# **Pentium® Pro Processor Specification Update**

Release Date: September 1998

Order Number: 242689-031

**Figure 4-3. Stack Switch on a Call to a Different Privilege Level**

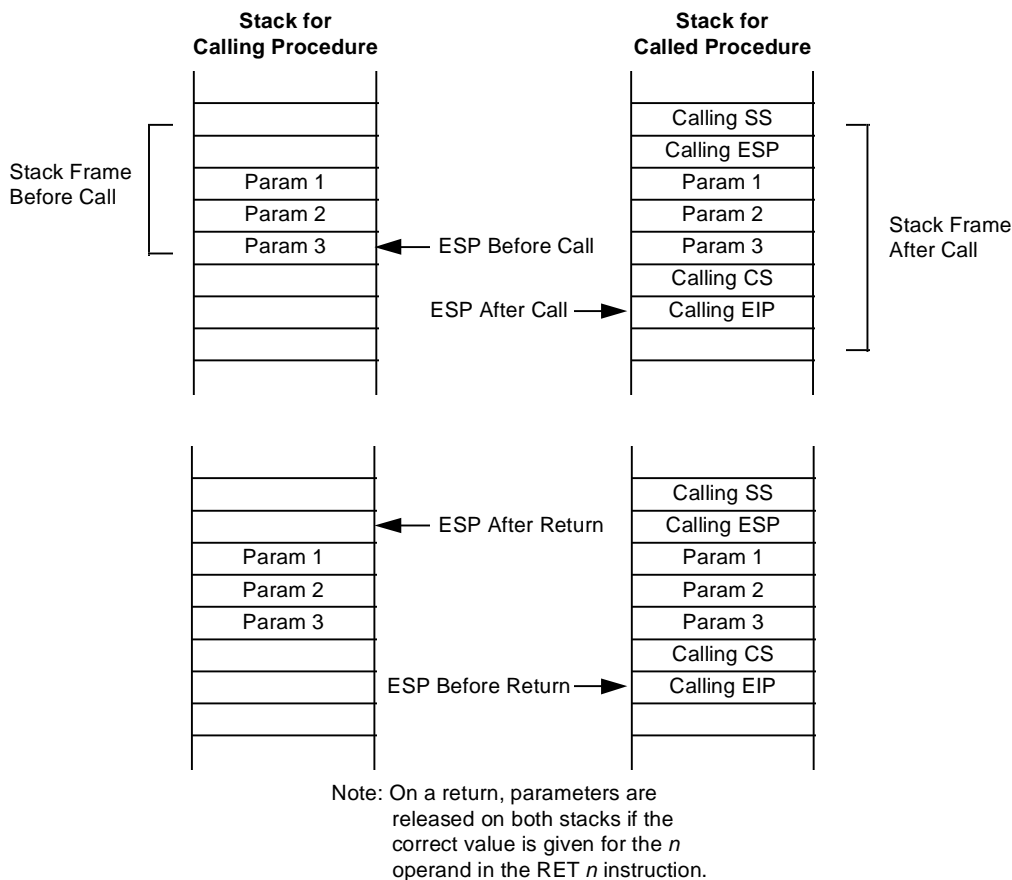
When making a call to a more privileged protection level, the processor does the following (see Figure 4-3):

4. Restores the SS and ESP registers to their values prior to the call, which causes a switch back to the stack of the calling procedure.
5. (If the RET instruction has an optional n argument.) Increments the stack pointer by the number of bytes specified with the n operand to release parameters from the stack (see explanation in step 3).

6. Resumes execution of the calling procedure.

**Figure 4-4. Stack Usage on Transfers to Interrupt and Exception Handling Routines**

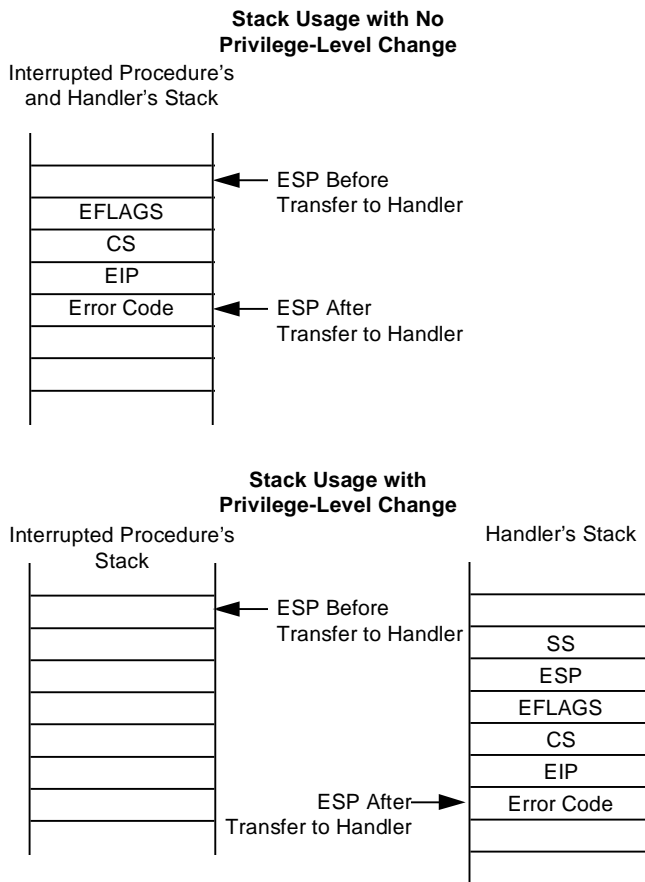
If no stack switch occurs, the processor does the following when calling an interrupt or exception handler (see Figure 44):

1. Performs a privilege check.
2. Restores the CS and EIP registers to their values prior to the interrupt or exception.
3. Restores the EFLAGS register.

4. Restores the SS and ESP registers to their values prior to the interrupt or exception, resulting in a stack switch back to the stack of the interrupted procedure.
5. Resumes execution of the interrupted procedure.
